**Request for City Council Committee Action
from the Department of Community Planning and Economic Development –
Planning Division**

Subject: William Wells has filed an appeal of the City Planning Commission's decision approving a site plan review application for a new, 33-unit, multi-family residential building located at 721-729 8th Street SE in the I1/Industrial District and the IL/Industrial Living Overlay District and the UA/University Area Overlay District. Specifically, the appeal is related to the site plan condition of approval that the proposed pitched roof on the building be replaced with a flat roof (condition of approval # 5).

**1. Apartment Building, 721-729 8th St SE, Ward 3
Staff report by [Aaron Hanauer](#), BZZ-7077**

Background/Supporting Information: William Wells has filed an appeal of the City Planning Commission's decision approving a site plan review application for a new, 33-unit, multi-family residential building located at 721-729 8th Street SE in the I1/Industrial District and the IL/Industrial Living Overlay District and the UA/University Area Overlay District. Specifically, the appeal is related to the site plan condition of approval that the propos

721-729 8th St SE Apartments - Rendering showing Zoning Staff's conditions of approval - flat roof removing all gable roof elements

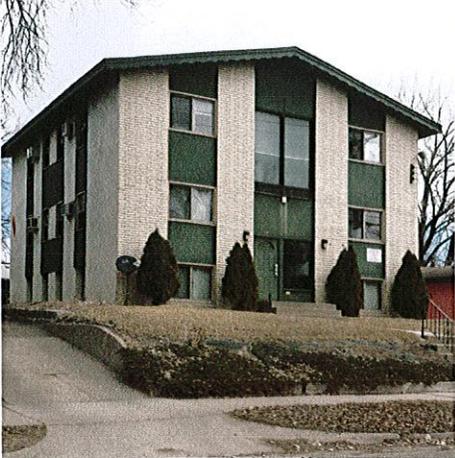
Please support the appeal and remove Zoning Staff's condition of approval that *the pitched roof on the primary building be replaced with a flat roof.* This requirement adds significant cost to the project and is counter to the goal of building an affordable bike friendly housing project.

Flat roof with parapet, building looks taller from sidewalk.
Flat roof adds a lot of cost, makes building less affordable

FIELD SURVEY OF BUILDINGS ON 8th ST SE. 85% OF BUILDINGS HAVE A HIP OR GABLE ROOF

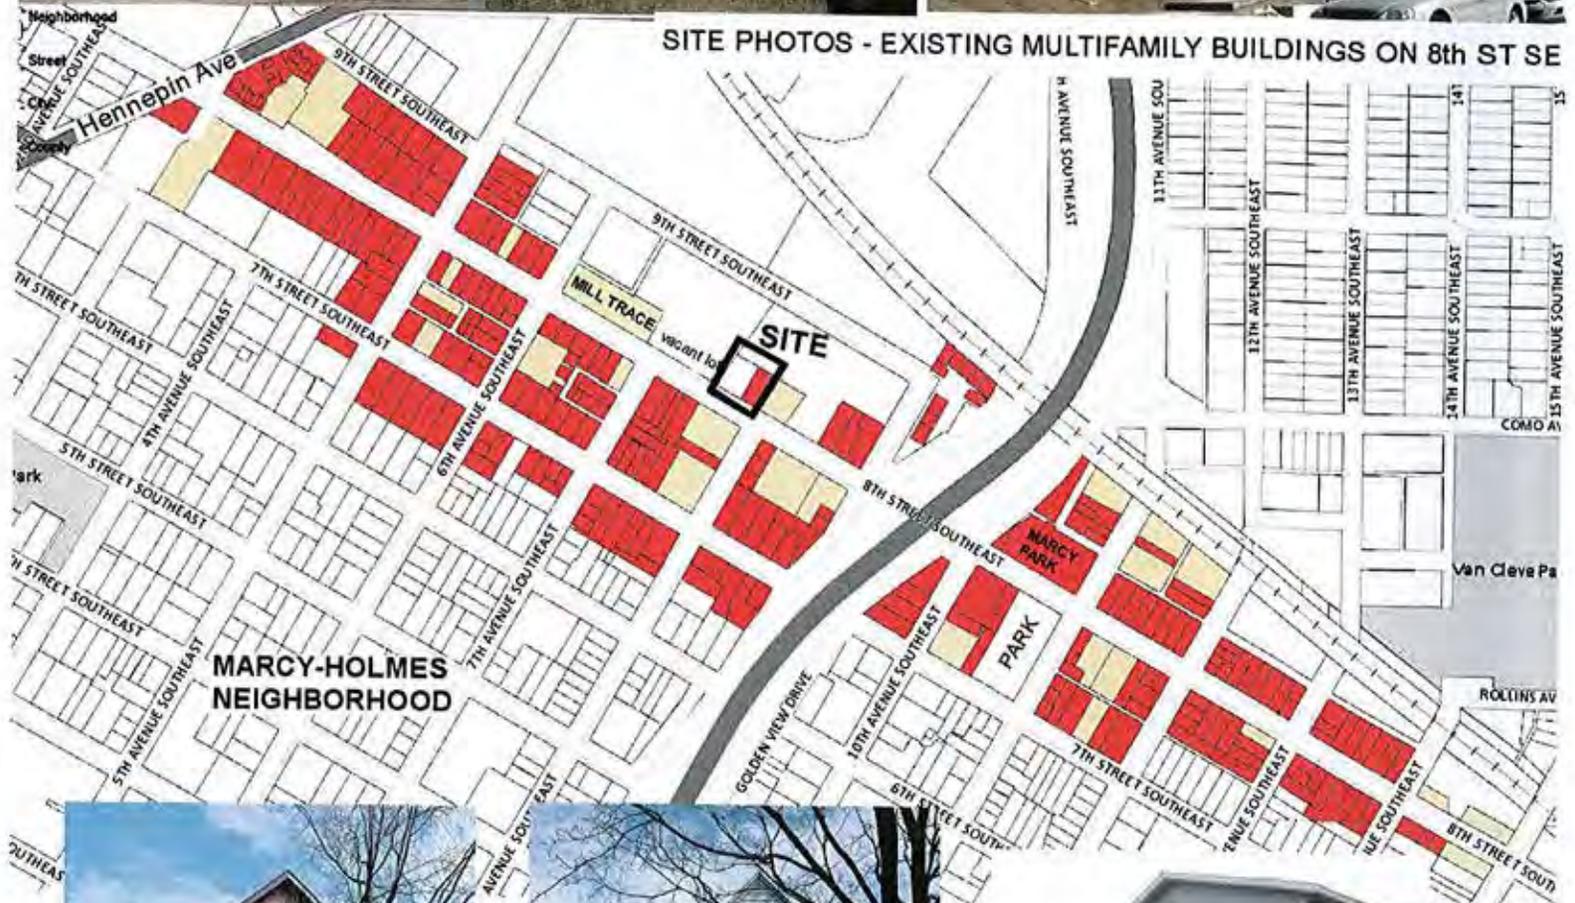
- **The form and pitch of roof lines shall be similar to surrounding buildings.** The proposed building has a hipped roof with dormers. The neighboring multiple-family dwellings and the industrial buildings from 6th Avenue Southeast to 9th Avenue Southeast have flat roofs. Alternative compliance is required. The intent of this site plan review standard for roof styles is to help new construction relate to its immediate surroundings. The applicant completed an analysis of buildings in the neighboring area and states that 85 percent of the buildings in the studied area have pitched roofs. In this analysis, the applicant included the low-density residential properties (i.e. non-apartment buildings) and excluded the flat-roof industrial buildings along 9th Street Southeast. CPED is recommending that the Planning Commission not provide alternative compliance to allow for the pitched roof and that the building shall have a flat roof. The flat roof will help the proposed building better relate to the other apartment buildings in the area, the immediate neighbors on the east and west of the projects site and industrial buildings in the immediate area. Furthermore, it will reduce the overall height of the building, which will help it better relate to the two and three story buildings in the area.

5. Per 530.120 (c), the pitched roof on the primary building shall be replaced with a flat roof.
6. Per 530.170 (e), a seven-foot wide landscaped tree island shall be installed within the parking area to accommodate the on-site deciduous tree.
